HI-STORE

Chapter 2 & Environmental Report RSIs

- **RSI 2-5**

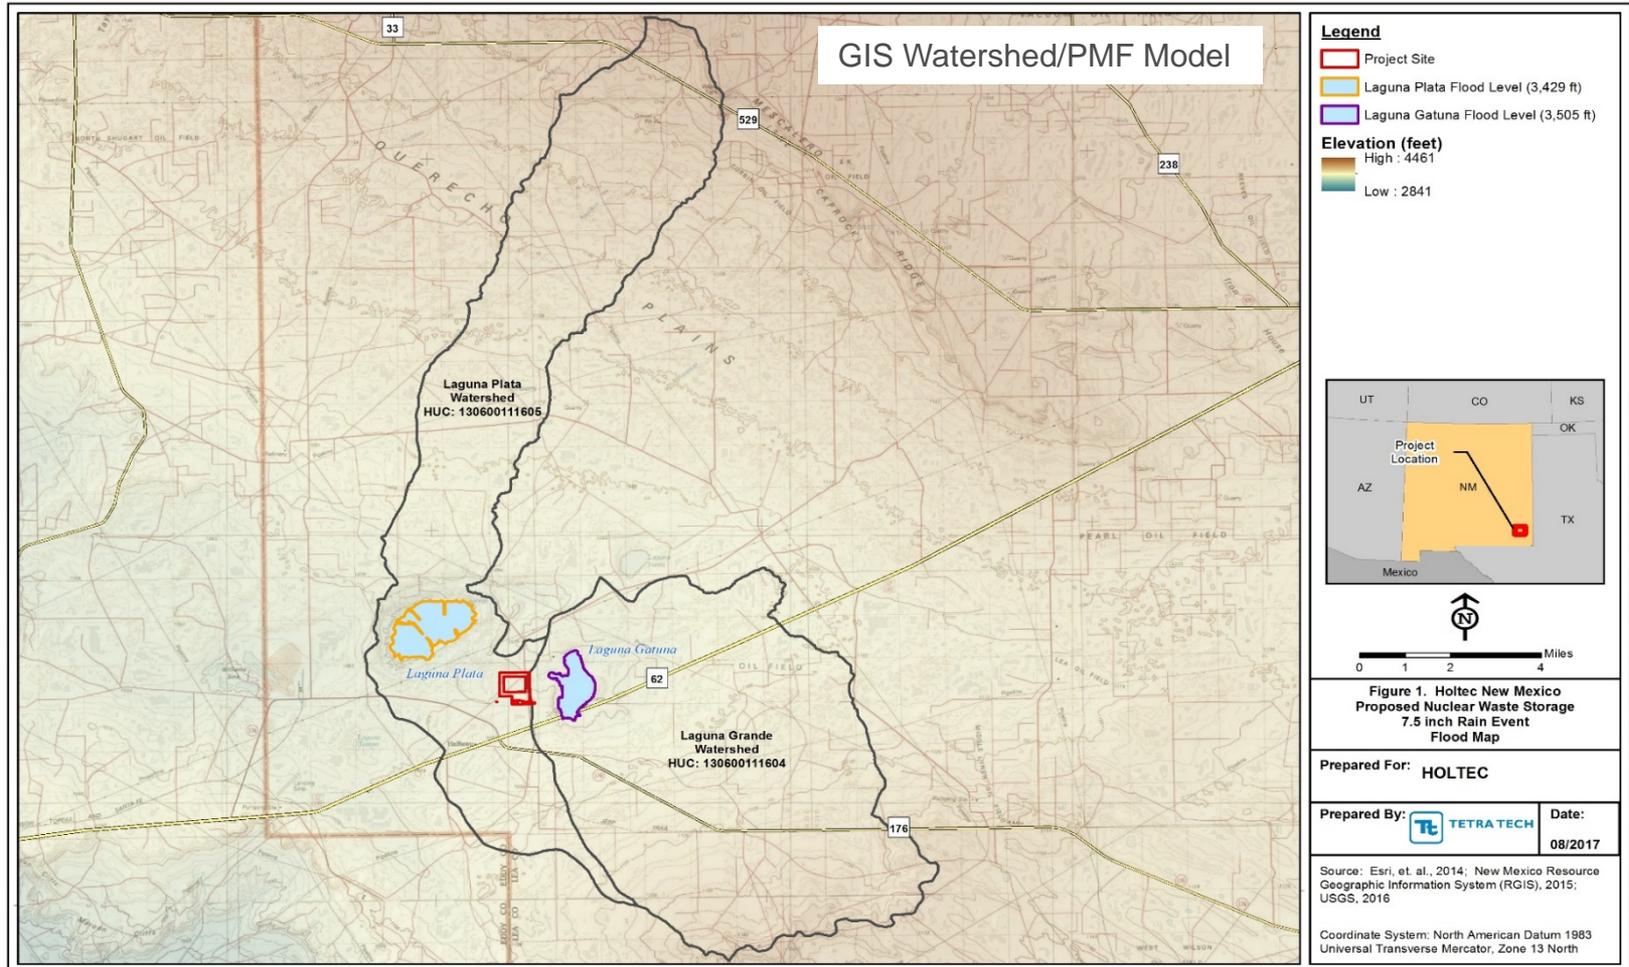
- Requested information includes:
 - Information describing hydrologic characteristics of the site.
- Strategies to respond
 - Additional data compiled from:
 - Federal Emergency Management Center Flood Map Service Center
 - State of New Mexico Interstate Stream Commission, Lea County Regional Water Plan 2016
 - U.S. Fish and Wildlife Service, National Wetlands Inventory
 - Western Regional Climate Center, Hobbs, Lea County Airport Data
 - Etc.
